Access Compliance Report

Public Rights-of-Way

Intersection ID: N/A	Main Street: INVERNESS_BAY_RD	Cross Street: ELGIN_MOOR_RD	Location: NW
ADA ID: 1FEB2786C4C3	Ramp Type: Perp	Initial Pass/Fail: Fail	Overall Compliance: No
		Severity Score: 22.5

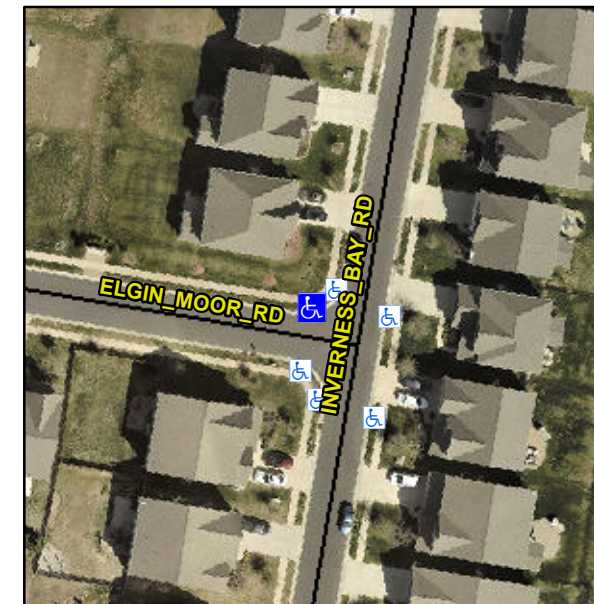
R304.5.1, R304.2.2, R304.5.3

Compliance	Description	Data	Compliance	Description	Data
N/A	Ramp Length (in)	49.0	No	Ramp Slope (%)	10.7
No	Ramp Width (in)	47.0	No	Ramp XSlope (%)	3.0
N/A	Flare Type LT	N/A	N/A	Flare Type RT	N/A
N/A	Flare Slope LT (%)	N/A	N/A	Flare Slope RT (%)	N/A
N/A	Flare Traversable LT?	N/A	N/A	Flare Traversable RT?	N/A
N/A	Landing Length (in)	N/A	N/A	DWS Provided?	N/A
N/A	Landing Width (in)	N/A	N/A	DWS Contrast?	N/A
N/A	Landing Slope (%)	N/A	N/A	DWS Length (in)	N/A
N/A	Landing X Slope (%)	N/A	N/A	DWS Full Width?	N/A
N/A	Landing Curb? (Y/N)	N/A	N/A	DWS Offset (in)	N/A
N/A	Shared Landing?	N/A			
N/A	Gutter Ponding?	N/A	N/A	Gutter Slope (%)	N/A
N/A	Gutter Lip Ht (in)	N/A	N/A	Gutter X Slope (%)	N/A
N/A	Painted X Walk1?	No	N/A	Painted X Walk2?	N/A
	X Walk 1 Direction	To SW		X Walk 2 Direction	N/A
N/A	X Walk 1 Width (in)	N/A	N/A	X Walk 2 Width (in)	N/A
	X Walk 1 Slope (%)	3.1		X Walk 2 Slope (%)	N/A
	X Walk 1 X Slope (%)	1.2		X Walk 2 X Slope (%)	N/A

Remove & Replace Entire Ramp.
